KNOXVILLE HISTORIC ZONING COMMISSION STAFF REPORT - CERTIFICATE OF APPROPRIATENESS APPLICATION

► FILE NO: 1213074&G

IIII Luttrell

1111 Luttrell. Certificate No. 1213074&G. Knoxville Historic Zoning Commission Meeting of February 21, 2008

Current North Elevation at rear of house

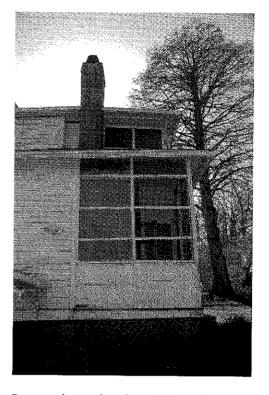
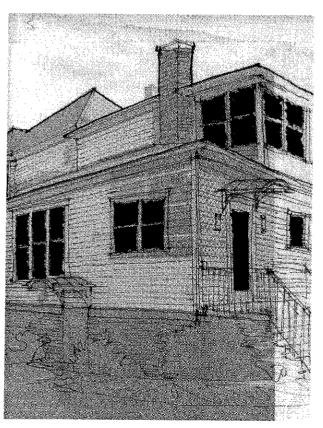
Proposed new framing, siding, windows and door

Current West Elevation at rear

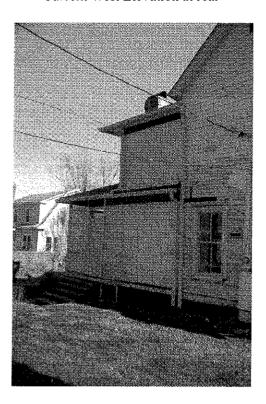
- · EXISTING AWNING OVER BASEMENT DOOR TO BE REPAIRED
- NEW AWNING OVER NEW DOOR TO MATCH EXISTING ANNING WERE BASEMENT DOOR

Existing site plan for main structure, outbuilding and driveway

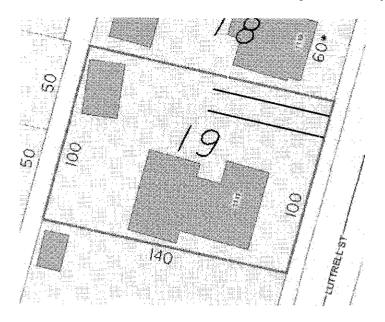
Proposed location of parking pad (dashed line)
